**AQUA SCIENCE ENGINEERS, INC.
2411 OLD CROW CANYON RD., #4
SAN RAMON, CA 94583**

September 30, 1992

SUBJECT: Workplan
Groundwater Contamination Assessment, No. 2571
The Oliver Rubber Company
1200 65th Street
Emeryville, CA

SITE PLAN

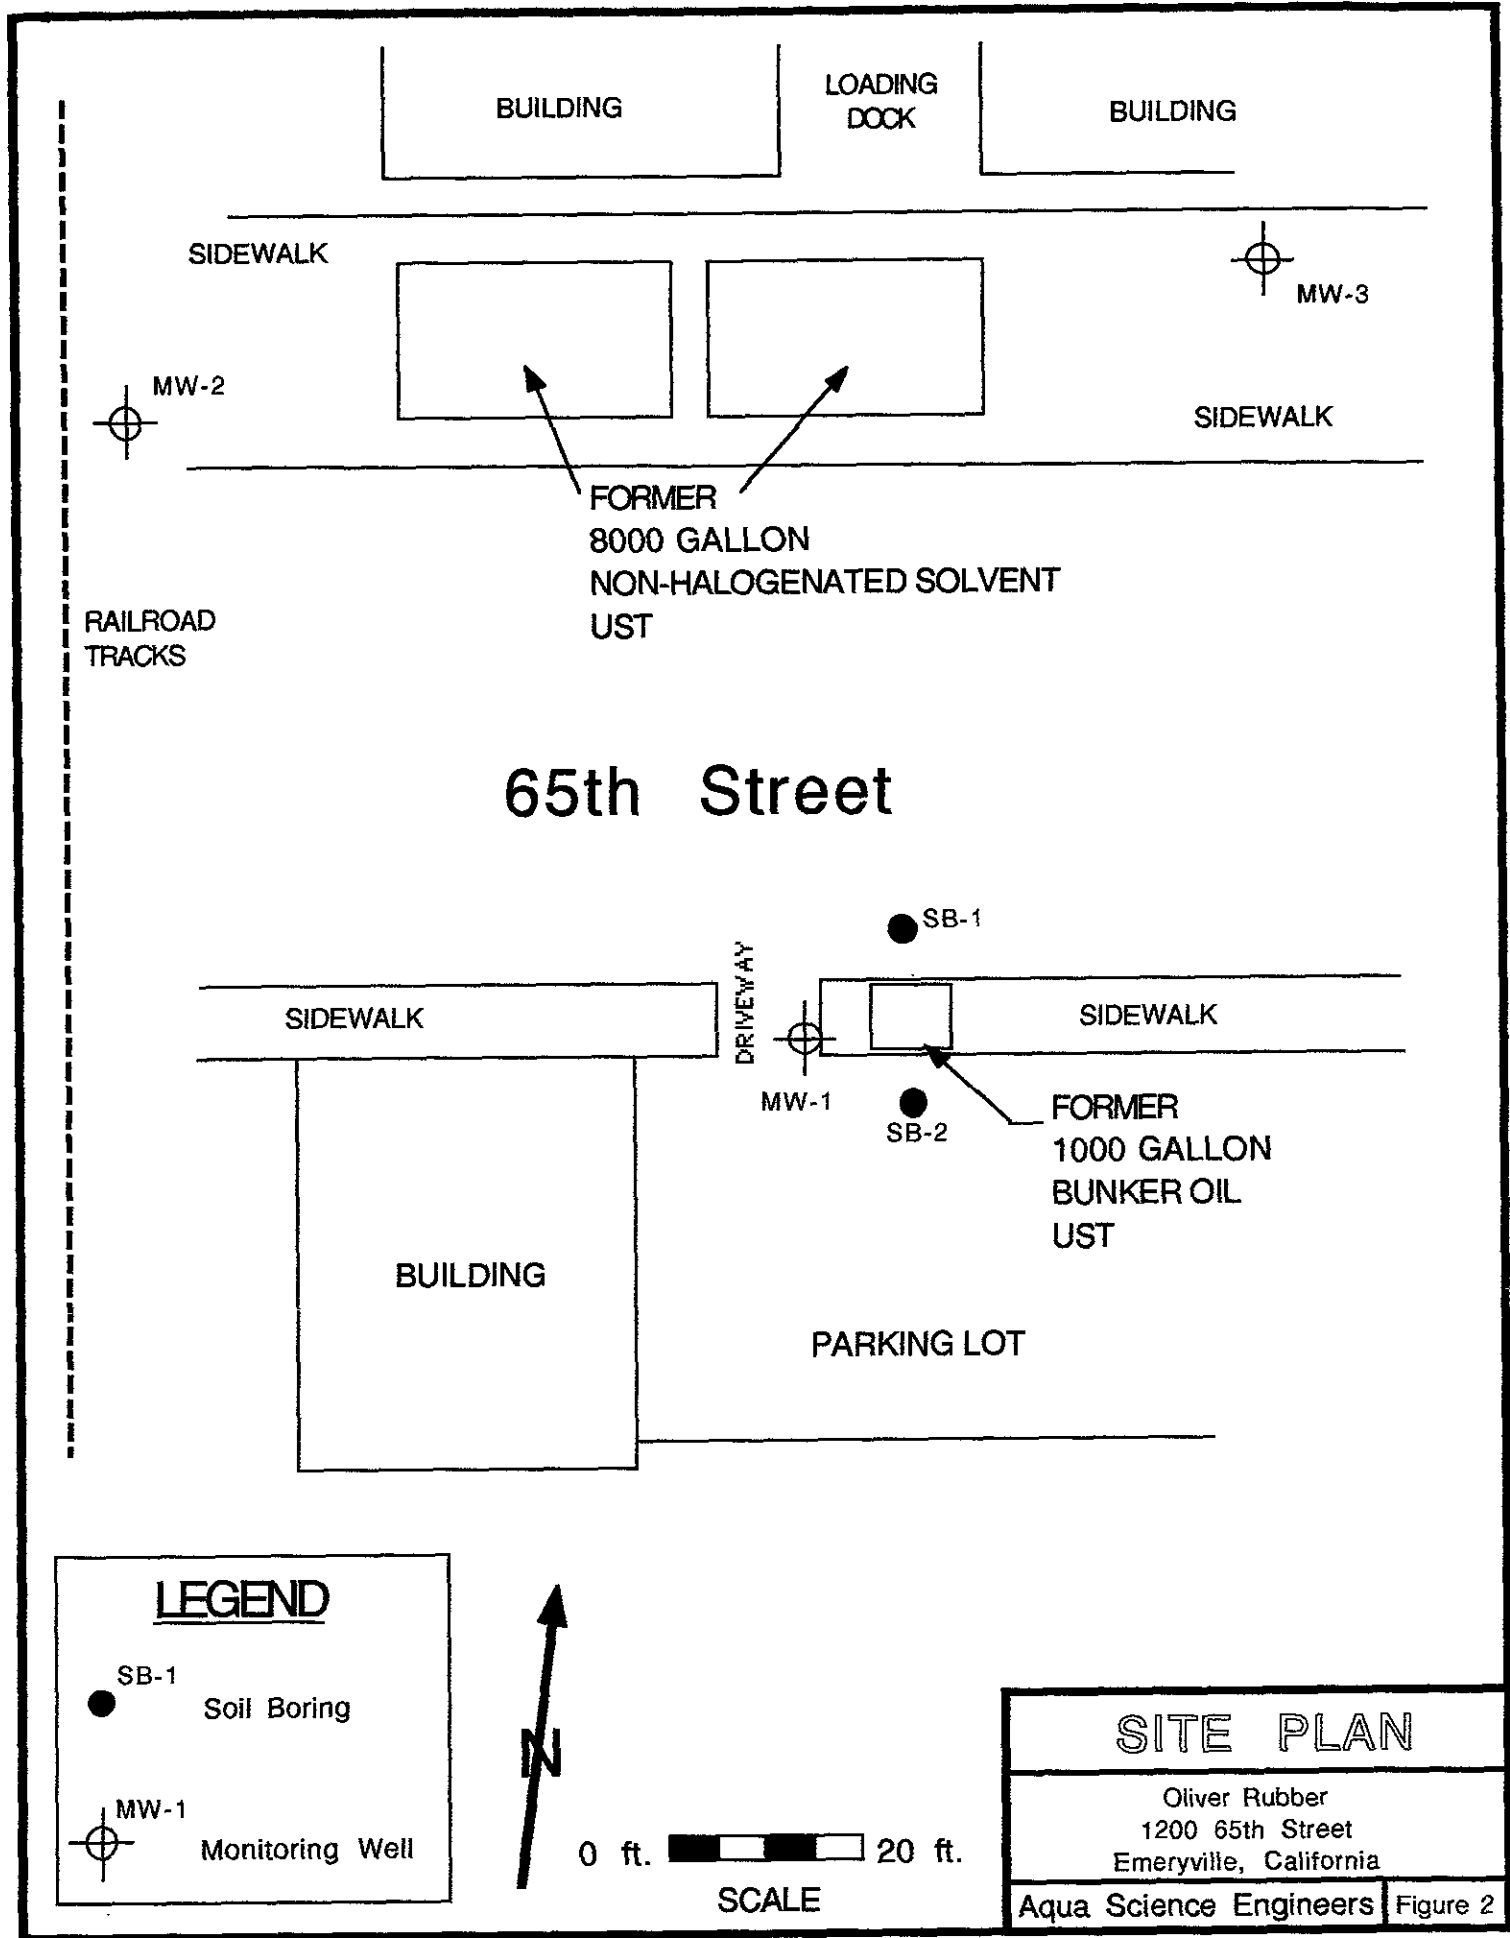
Due to minor levels of semi-volatile organics, specifically 2-Methylnaphthalene (0.38 ppm) found in stockpiled soil associated with the former bunker tank excavation, soil samples will be collected at 5-foot intervals (beginning at or near 5 feet to the capillary fringe) in the three borings located in the area of the former tank excavation (SB-1, SB-2, and MW-1), see the attached Site Plan for boring/well locations. MW-1 will be located within 10 feet to the west/northwest (assumed

1. Only submit the "capillary-fringe soil sample" extracted from MW-1 for analysis by EPA method 8270 initially (other soil samples will be held by the lab awaiting ASE direction). ASE's R.G. feels that if the semi-volatile organic constituents are present, they will be found in the soil at the "capillary fringe".
2. If EPA method 8270 analytical results show **non-detectable** levels of 2-Methylnapthalene in soil at the location and depth described above in MW-1, then ASE will not have SB-1 and SB-2 "capillary-fringe soil samples" submitted for analysis by EPA method 8270.
3. If EPA method 8270 analytical results show **detectable** levels of the 2-Methylnapthalene in soil at the location and depth described above in MW-1, then ASE will have the SB-1 and SB-2 "capillary-fringe soil samples" and the MW-1 groundwater samples analyzed by EPA method 8270.

These options will limit the number of samples submitted initially for analysis by EPA method 8270 if the MW-1 "capillary-fringe soil sample" shows non-detectable levels. We have chosen this specific sample location and depth as the "significant" location because it is located in the assumed down-gradient direction of the former bunker oil tank excavation. If the 2-Methylnapthalene does not appear in the soil at the MW-1 (assumed down-gradient location), then it is reasonable to assume it will not be found at the lateral or up-gradient location.

Approved verbally to implement workplan per 8270. analysis of groundwater for Hugo 10/1/92

*10/1/92 Site visit. 10:30-11:30
Talked to David Allen re: 8270 for both soil & groundwater.*
